Crescent Newcastle Pty Ltd  
Proposed Development 11-17 Mosbri Crescent, The Hill

**MINE SUBSIDENCE REPORT**

6 May 2021

**FIG 3:** – 'Lot Boundaries and Proposed Grout in the Borehole Seam: Preferred Option 2, DgS Report No. COF-009/2 prepared by Ditton Geotechnical Services dated 22 August 2020

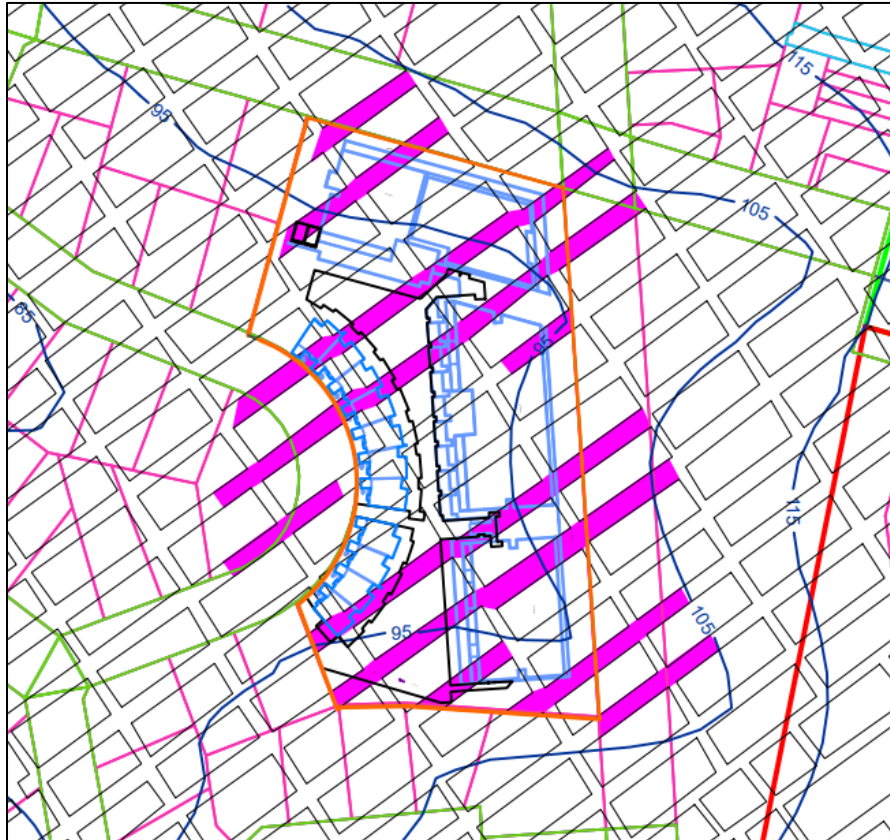
The modelling completed by DgS, and reviewed by GAPL, does not require the grout in the Boreholes Seam to be "*hard up against the roof*" in all mine headings, as the requirement is to strengthen the sides of the coal pillars, and not hold up the roof. For the Borehole Seam in the Current Mine Grouting Strategy, modelling utilises a conservative grout angle of repose of 1V:6H along the bords and 1V:10H across the bord assuming the more conservative 6m seam height with grout at the borehole taken to the roof.

A similar situation exists with the Current Mine Grouting Strategy and I also agree with DgS and the modelling does not require the cut-throughs to be grouted. I am also of a similar view to GAPL that it would be judicious to grout the cut-throughs. Whilst the Current Mine Grouting Strategy does not require cut-throughs to be targeted it is possible with the proposed grouting extending along pillars (rather than an isolated pillar in the original grouting strategy) that grout will flow into at least some cut-throughs. The DgS modelling also does not require grout to extend to the intersection on two coal pillars beneath the site as there are full rows of grouting in the adjacent roadway. I am of the view that it would be judicious to do this. This can be achieved by drilling from within the Subject Site.

**FIG 5:** Impact Classification with Deflection Ratios for Two Storey Brick Structures [1]

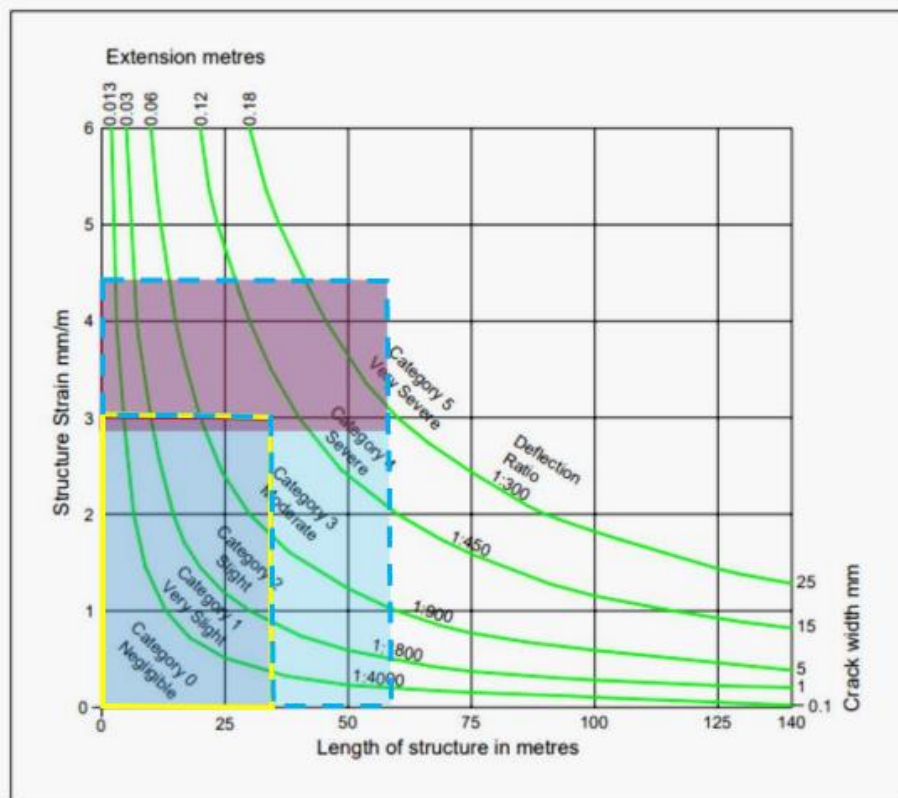
The zone enclosed by the yellow dashed line added by the author shows the possible damage category for 2-storey brick structures if the strains were  $<3\text{mm/m}$  and the building length  $<35\text{m}$ .

The zone enclosed by the yellow dashed line combined with the zone enclosed by the blue dashed line shows the possible damage category for 2-storey brick structures in the maximum strains were around  $4.5\text{mm/m}$  and the building length up to  $58\text{m}$ .

Based on Figure 5, it is expected most 2-storey brick structures would be in the "very slight to moderate" category.
